Countryside and Conservation
Landscape Comments

REFERENCE: 25/0226

PROPOSAL: SIDE AND REAR SINGLE STOREY EXTENSION AND RELOCATION
OF EXISTING OUT BUILDING

SITE: The Arch Bungalow, Watery Lane, Langstone,
Newport, NP18 2JY

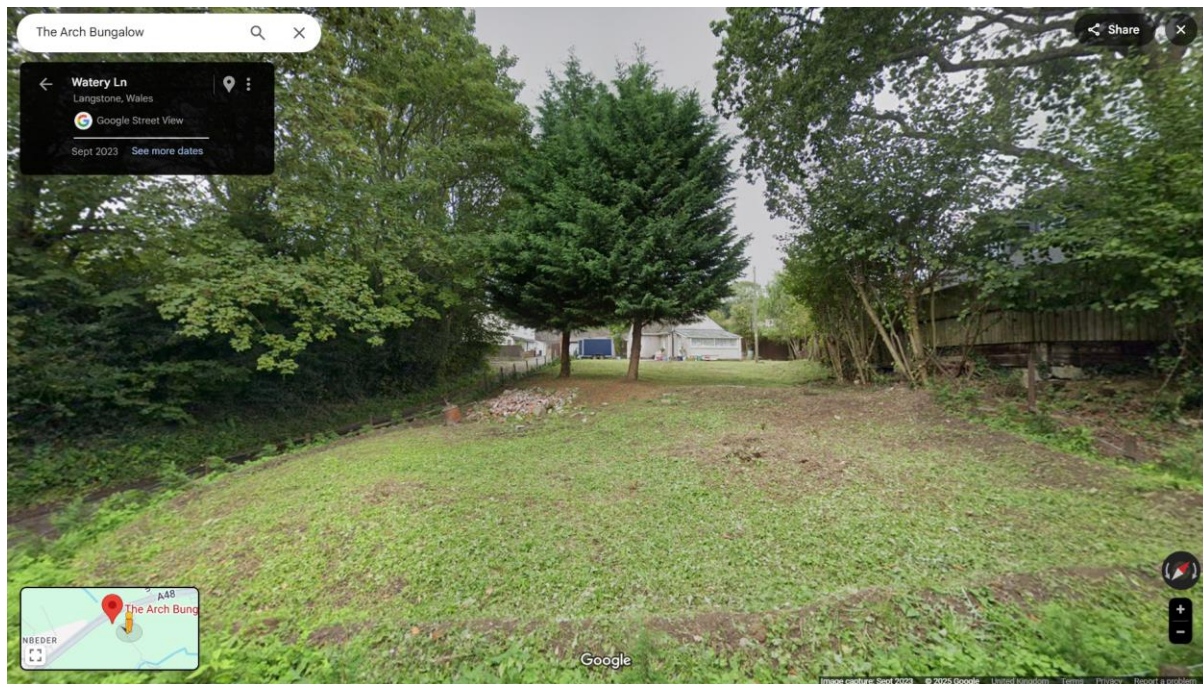
The site lies within the Bishton and Langstone ward adjacent to and south of the A48. Although the plot is sunken, it is still visible from the highway and there would be adverse visual impact on visual amenity with increased views of the proposed extension and outbuilding from the A48.

There would be an open but less significant view north of the development from Watery Lane.

It has also been observed that there is an existing tree to the north end of the existing bungalow which is likely to be impacted. If this tree is proposed to be removed, then replacement standard trees should be planted elsewhere on site at a ratio of 3:1.

To minimise, and mitigate the above impact on visual amenity, as well as enhancing landscape character and opportunities for biodiversity, a soft landscape scheme should be submitted for approval, to include features such as native hedgerow and tree planting. Some of these could be planted on the highway marginal land on the northern boundary. Details of all proposed planting of an appropriate specification for their position/function in the form of a planting plan, should be submitted for approval; to include:

Any alterations to the access drive including proposed parking such as resurfacing in the form of a hard landscape plan should also submitted for approval. Sustainable approaches to design would be supported. To include as appropriate:
